**OFFICIAL RESPONSE TO SIGNIFICANT ENVIRONMENTAL  
POINTS RAISED DURING THE TIMBER HARVESTING PLAN  
EVALUATION PROCESS**

**FROM THE DIRECTOR OF THE CALIFORNIA DEPARTMENT OF  
FORESTRY AND FIRE PROTECTION (CAL FIRE)**

TIMBER HARVESTING PLAN (THP) No:	1-20-00186-MEN
SUBMITTER:	Mendocino Redwood Co LLC
COUNTY:	Mendocino
END OF PUBLIC COMMENT PERIOD:	March 12, 2021
DATE OF RESPONSE AND APPROVAL:	May 6, 2021

### 1. COMMON CONCERN: Impacts to Hoe Road

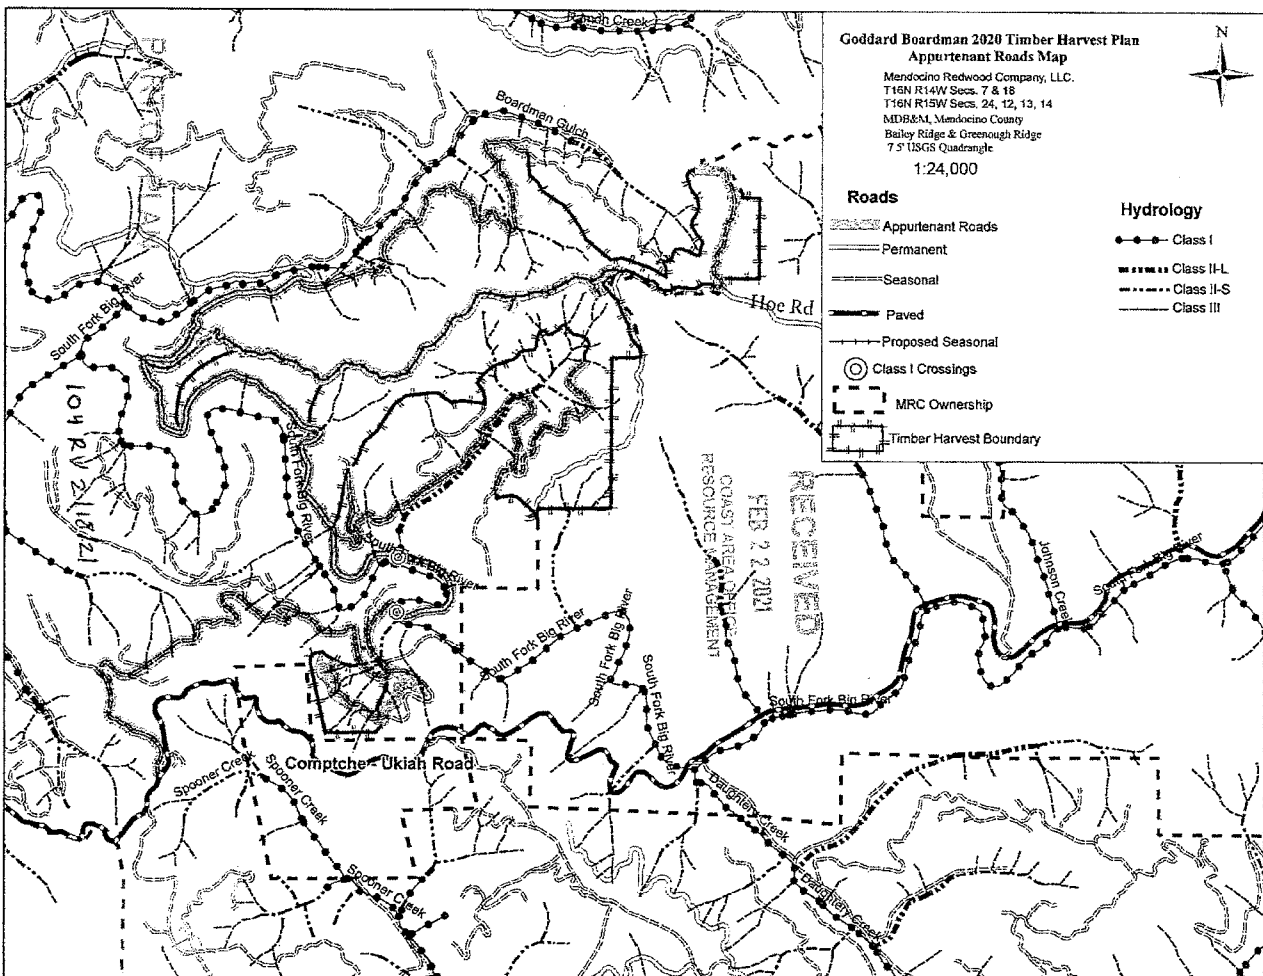
The public is concerned about impacts to Hoe Road, which is a private road and not maintained by the County of Mendocino. The common concern is as follows:

*Our road is maintained by the residents with our money and labor. We are demanding that NO loggers be allowed to drive to and from the job on Hoe Road. Loggers and MRC employees must use their own access roads to the plan.*

**RESPONSE:** The appurtenant roads are mapped on page 104 of the THP, which is shown below (reduced and not to scale). The grey highlighted roads will be used for timber operations leading to the Comptche- Ukiah Road. Approximately ½ mile of the Hoe Road is proposed to be used for timber operations because it is the only access to the northeast corner of the THP area. The majority of timber operations will be located to the west of Hoe Road and all traffic will use MRC roads. The FPRs (14 CCR 923.7) require all roads to be maintained and monitored during timber operations and 3 years after completion of operations during the prescribed maintenance period. The roads must be treated to prevent excessive loss of road surface materials, which is usually done by road watering:

CAL FIRE can't prohibit MRC from using the ½ mile of Hoe road. The Department has determined that the use of this road will be temporary to access the northeast corner of the plan and that all THPs roads will be maintained as described above.
